The FCC requested additional information in reference to the submission for certification of the Automatic Power Phalcon-2000 Radar Beacon. The data below and the attached data plots revises paragraphs 4.1.2, 4.3.1, and Appendix D of the SwRI test report entitled ‘‘FCC Measurement and Technical Report on the Automatic Power Incorporated Phalcon-2000 Radar Beacon,’’ dated November 1999 (report no. 99/129).

3840775
PJ

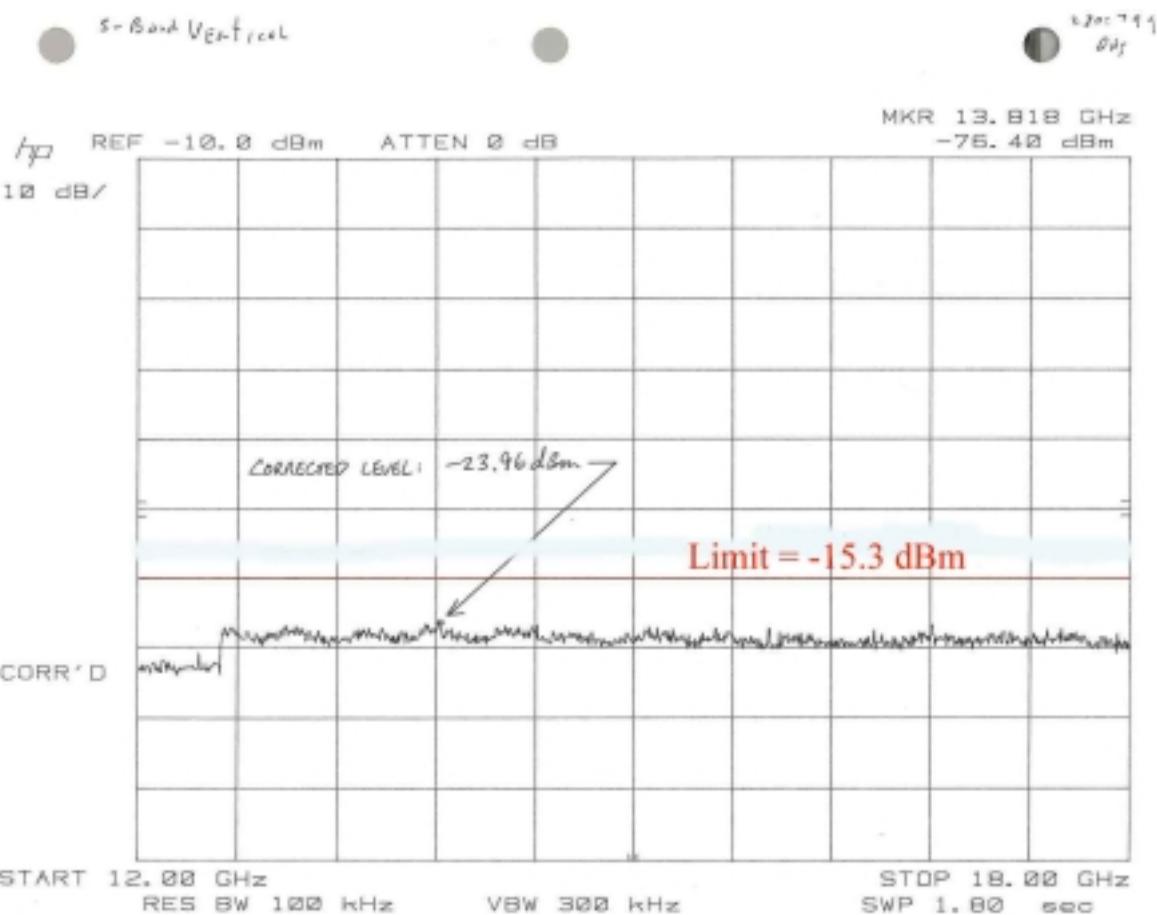
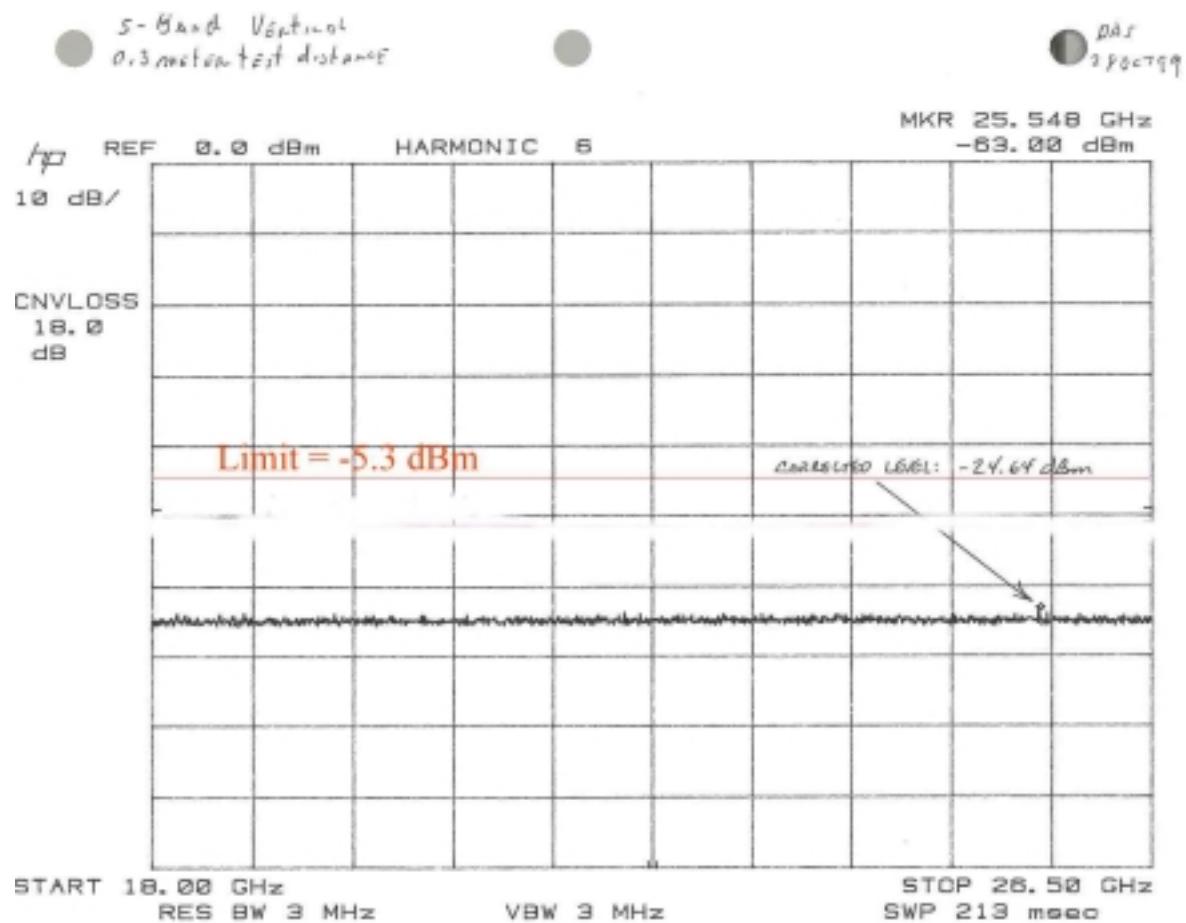
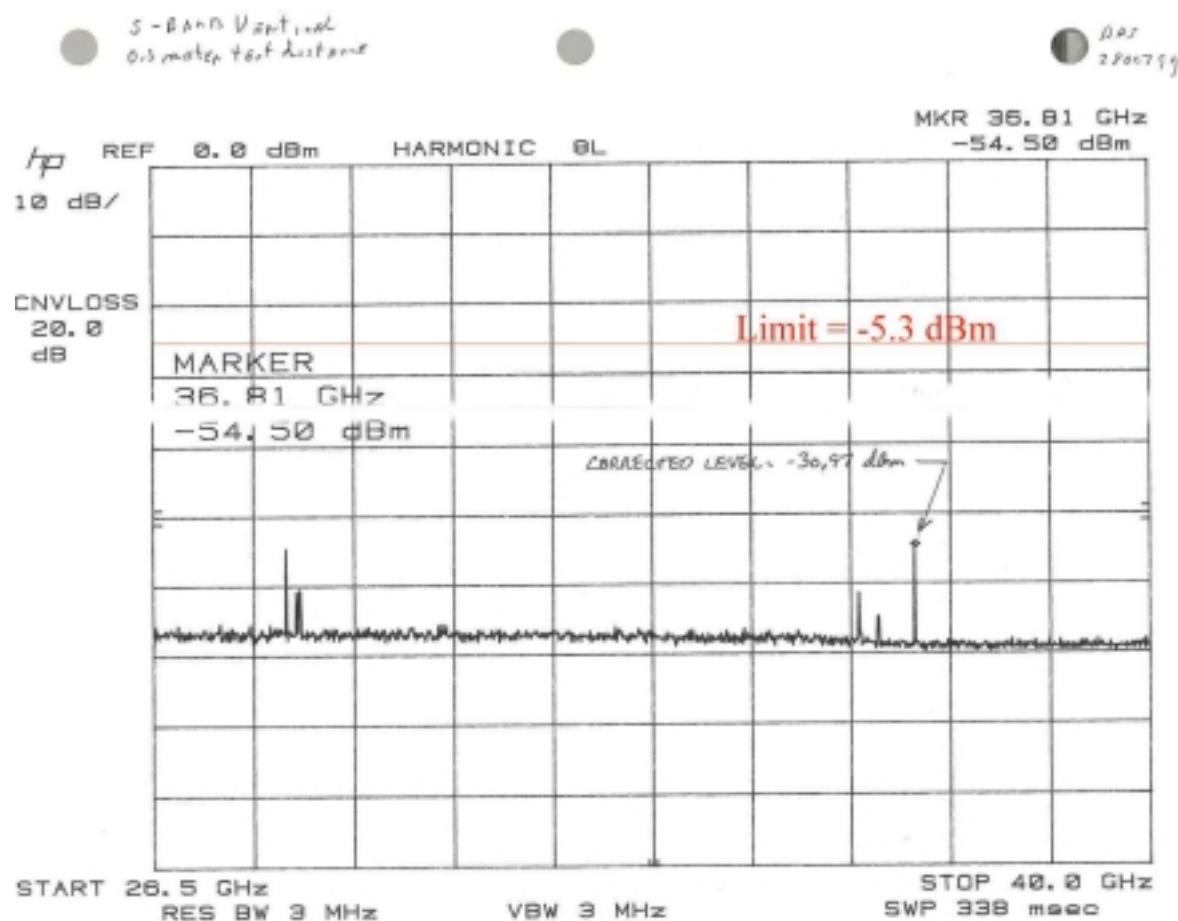
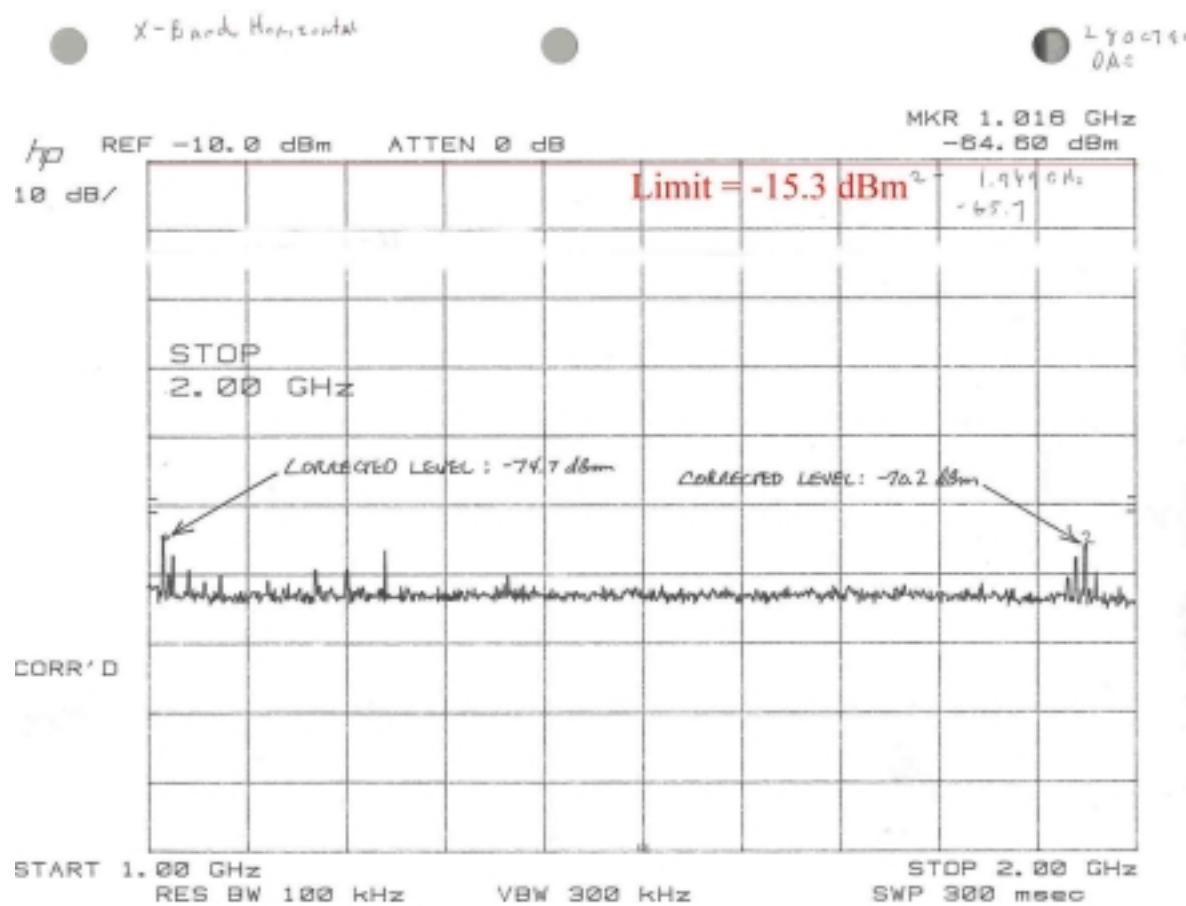
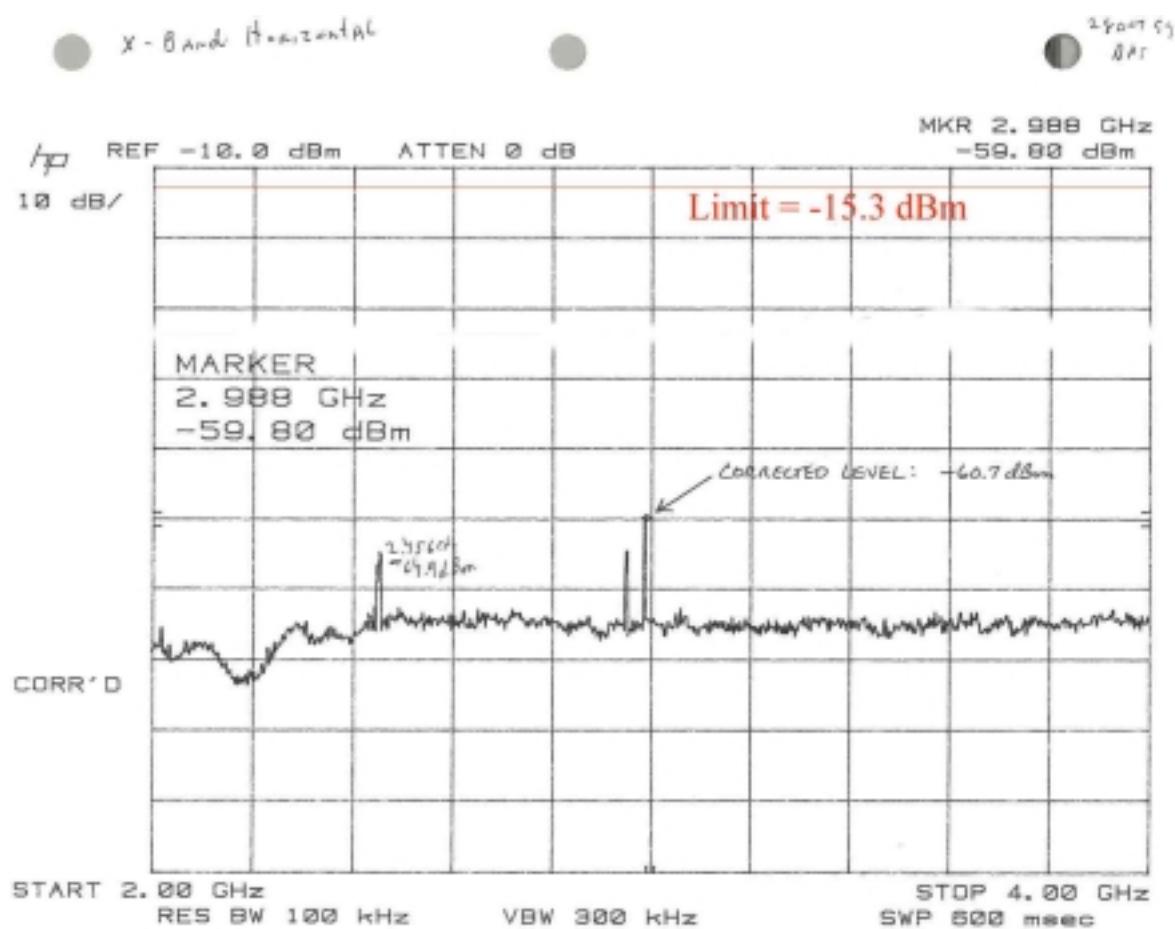
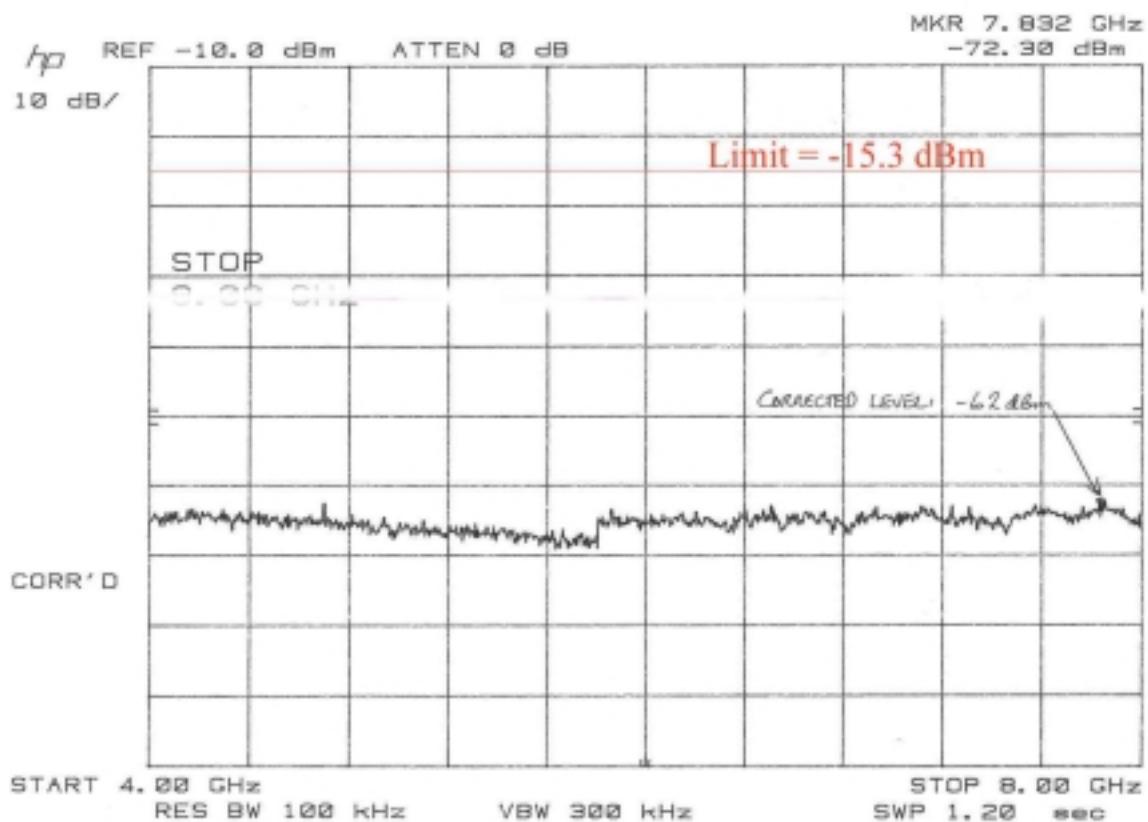
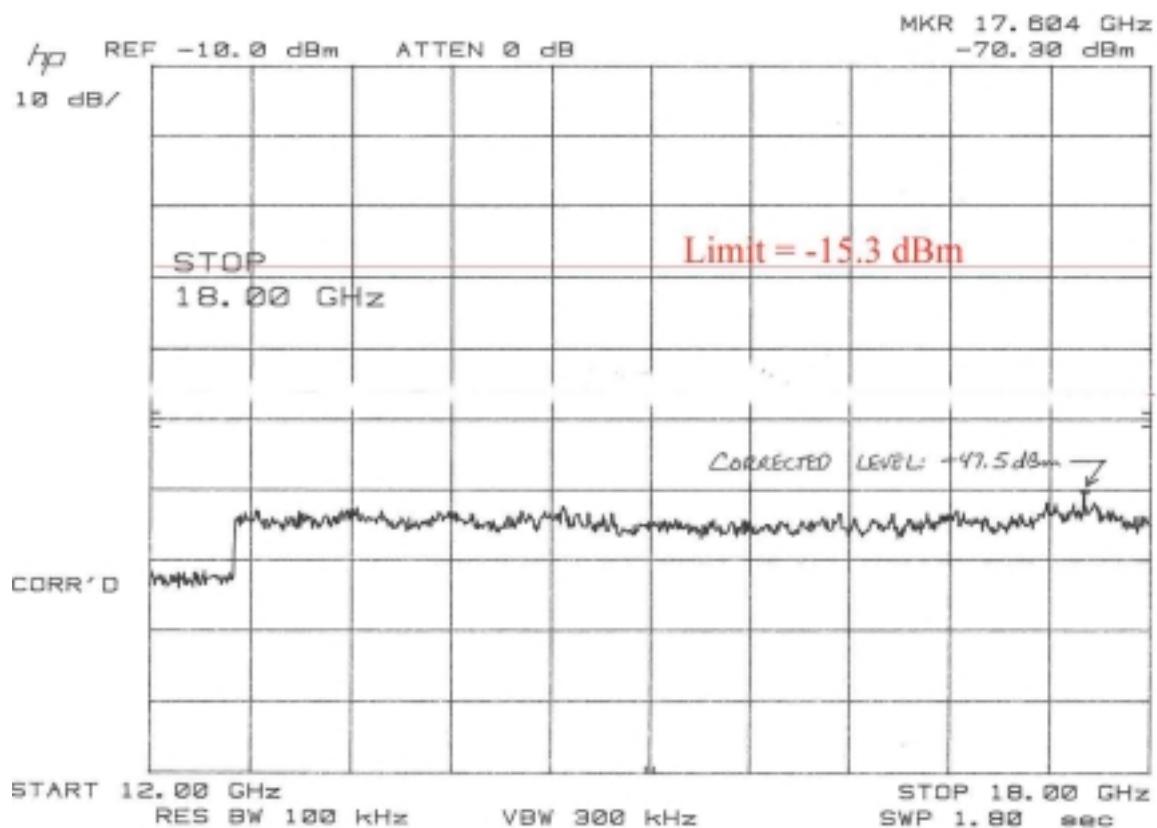
Question 2 from the FCC: *The attenuation specification for radiated spurious emissions should be computed on the basis of the (average) ERP. Please do this and report the results on that basis.*

The harmonics and spurious emissions were required to be 43 plus 10 log (average ERP in watts) dB below the fundamental emission:

Band		Limit
S	$43 + 10 \log (.238) \text{ dB} =$	36.8 dB (below fundamental)
X	$43 + 10 \log (.351) \text{ dB} =$	38.5 dB (below fundamental)

The data plots showing the radiated spurious emissions have been revised to show the corrected attenuation levels based on average ERP. These plots are attached to this letter. The worst case emission level was detected from the S-band, horizontal polarization, at 14.478 GHz, and was 5 dB under the limit.
